Application 3/2021/0275

Location: Land behind The Dog Inn, Market Place, Longridge PR3 3RR

Proposal: Proposed erection of 9 new dwellings and associated works

Site Section through The Dog Inn, Plot 2 and 36 Darwen Close

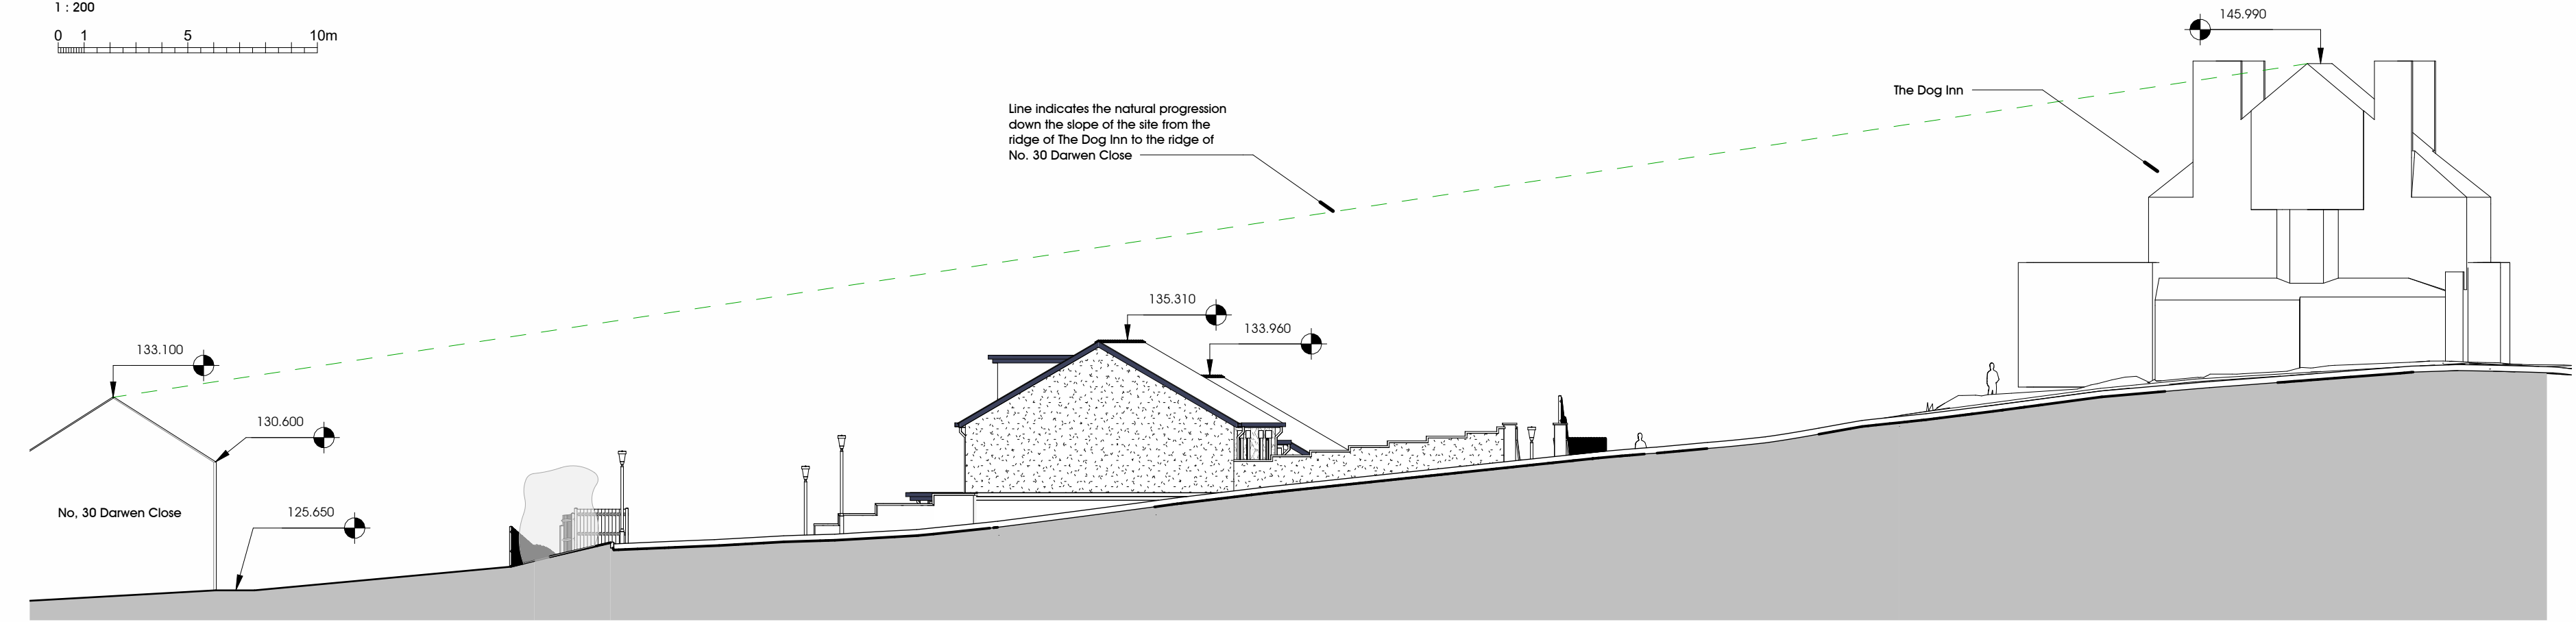
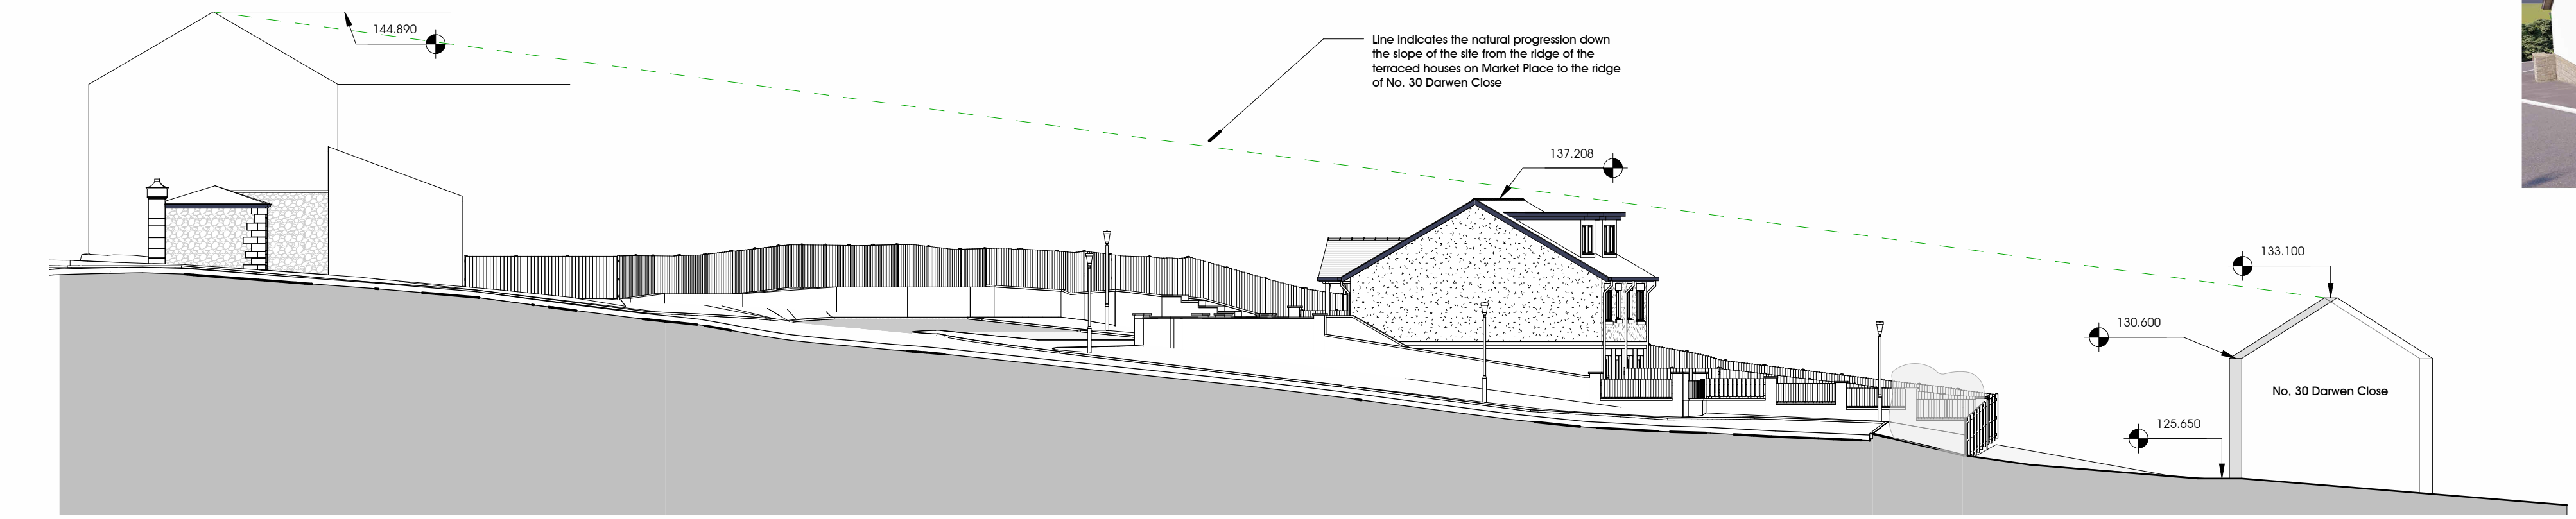
2. Details to demonstrate how any exceedance flows will be managed in practice for example through high kerbs and any raising of proposed ground levels. Details for any retaining wall structure and boundary treatment around the curtilage of the proposed properties with particular reference to plots 1 and 7.

Response: The access road has a fall that reflects the existing site levels, falling to the south east and then the south west. The manholes on the public foul sewer diversion are to lie within the proposed access road and parking areas, and therefore any exceedance flow from the manholes at the top of the site will flow along the access road away from the proposed properties. Those manholes within the southern part of the site are lower than the proposed properties and any exceedance flows will therefore not affect the proposed properties.

The drawings attached to this letter show the retaining walls and boundary treatment around the curtilage of the proposed properties.

PROPOSED DRAINAGE LAYOUT

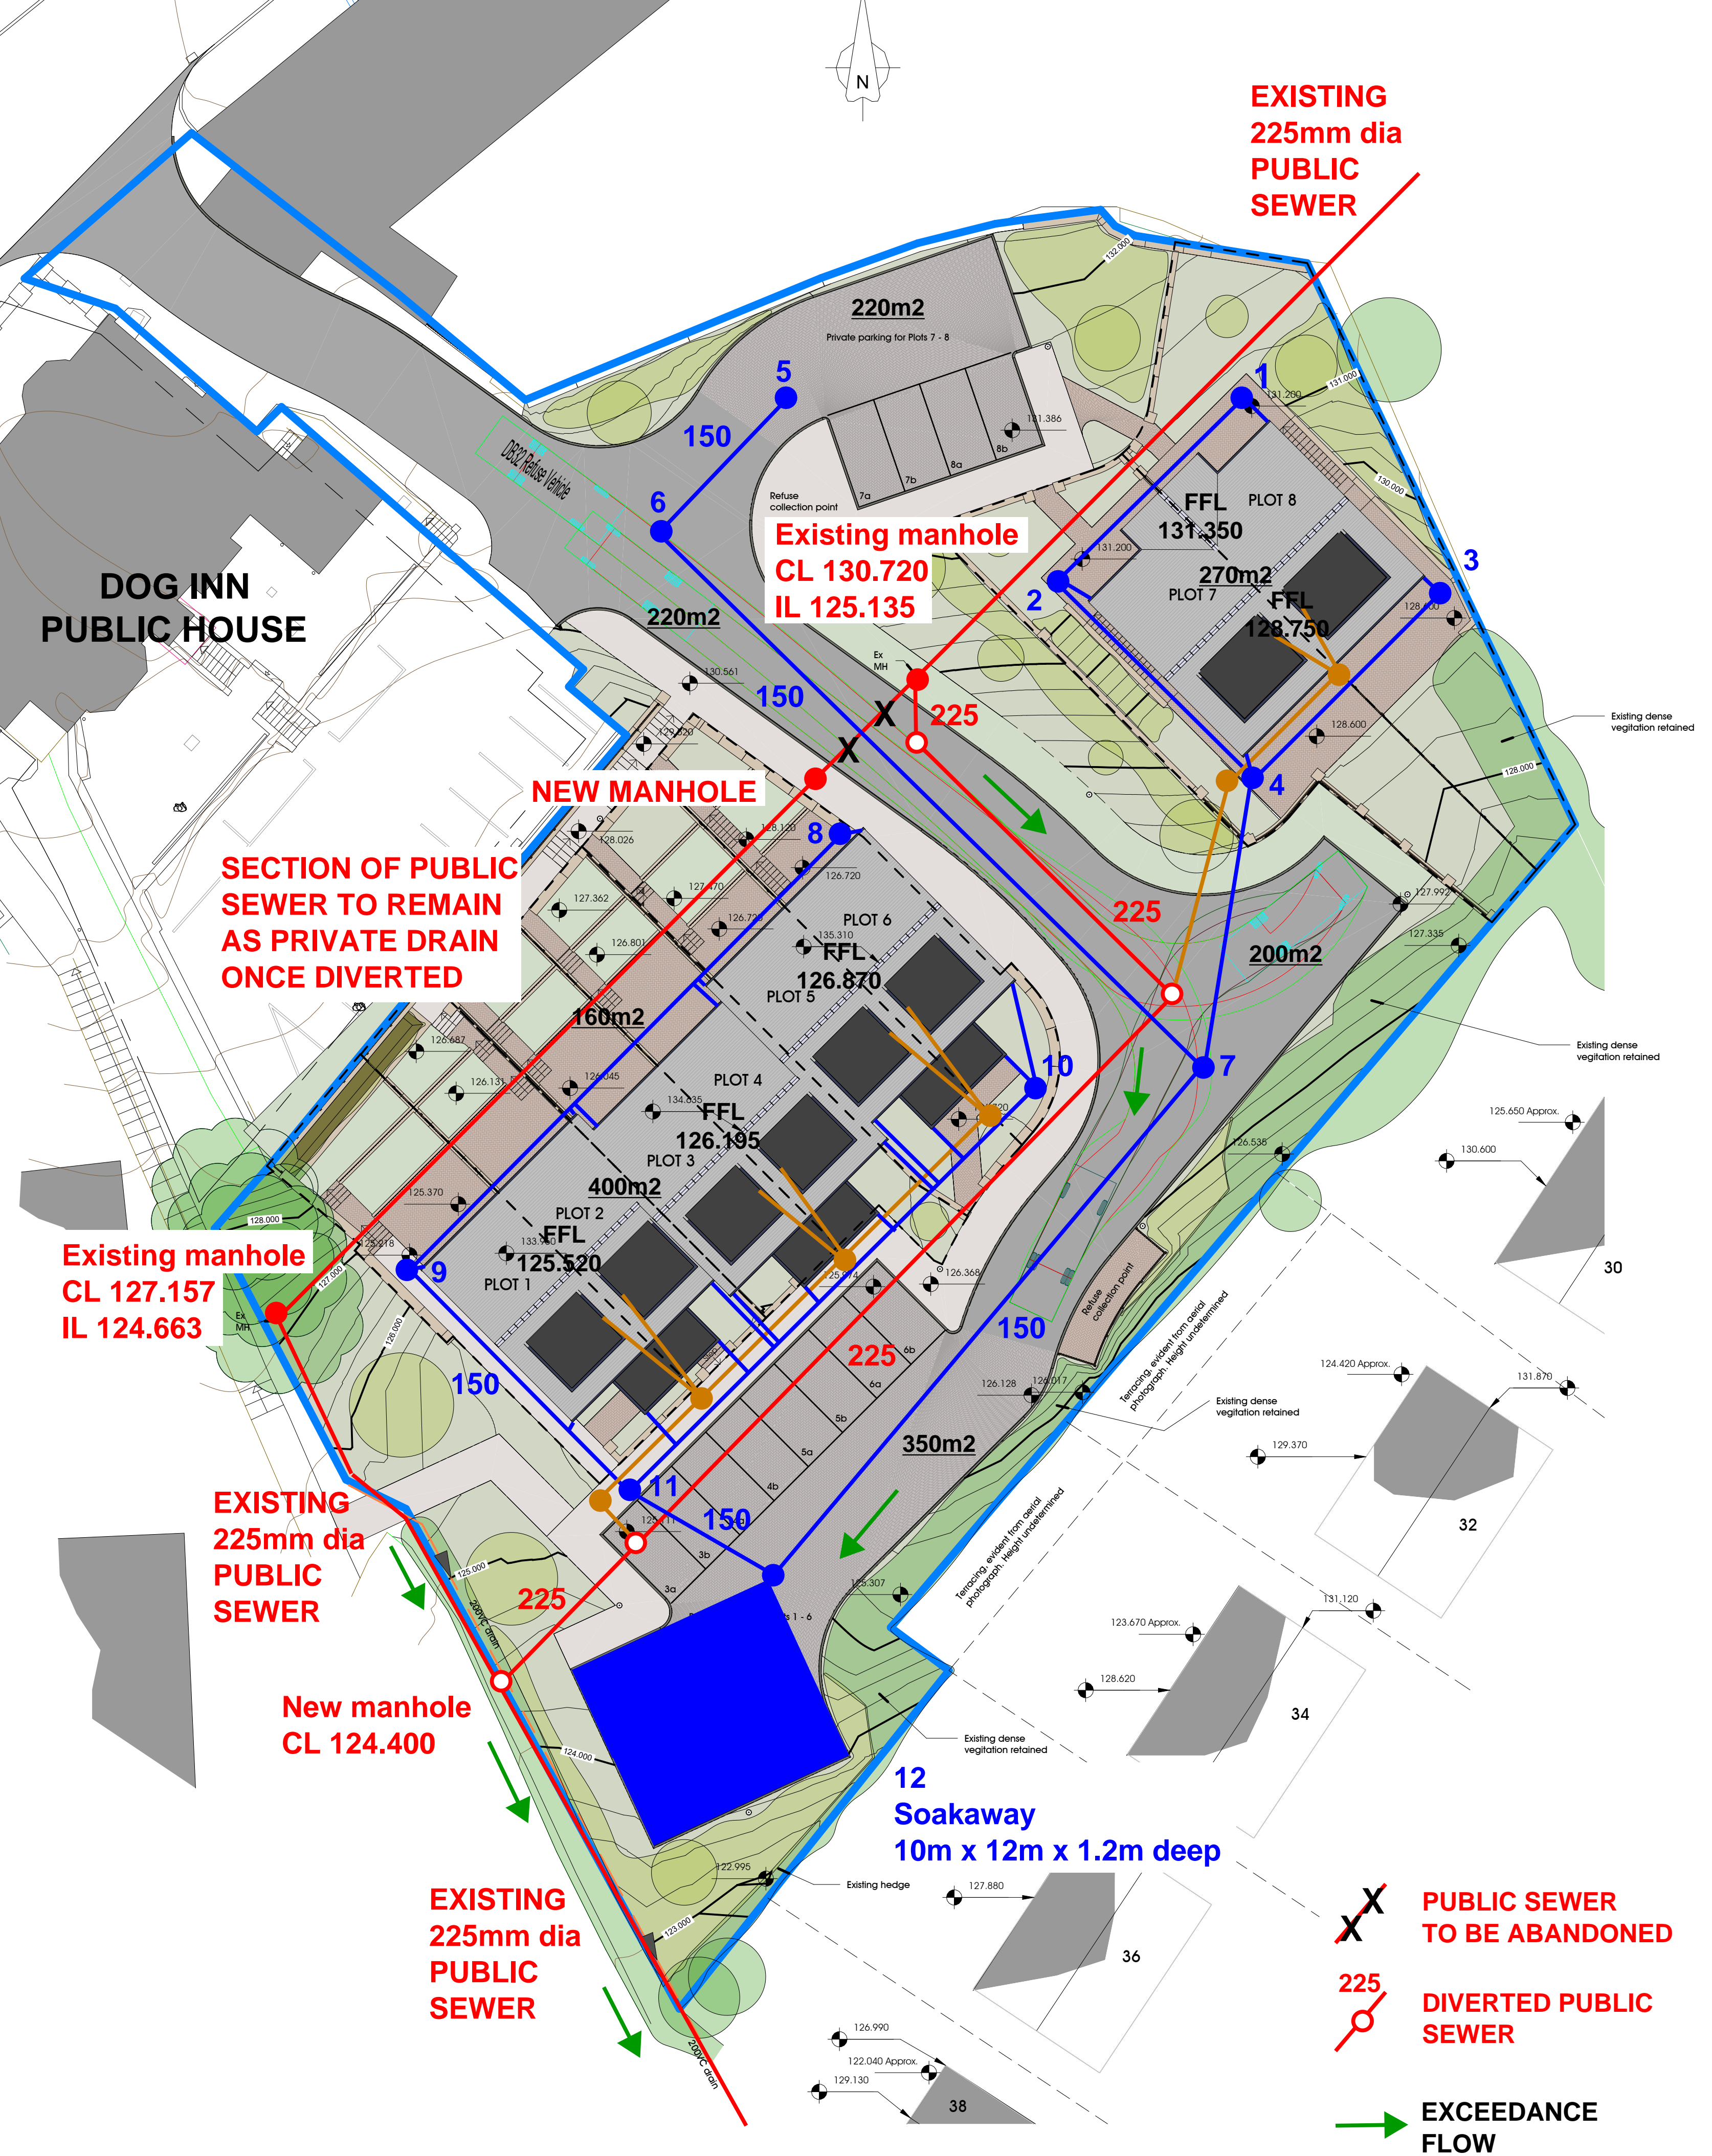
1. The finished floor levels for all proposed units and finished ground levels for the site. In addition further details for the surface water and foul water drainage arrangements are needed which is to include the proposed private drainage runs and connection points for each unit to the proposed drainage systems.

Response: We attach to this letter the proposed site layout that shows plot finished floor levels and ground levels, along with a drawing showing sections through the site. Further details for the surface water and foul water drainage arrangements have been added to the

proposed drainage layout, which is also attached, in addition to finished floor levels of the proposed units.
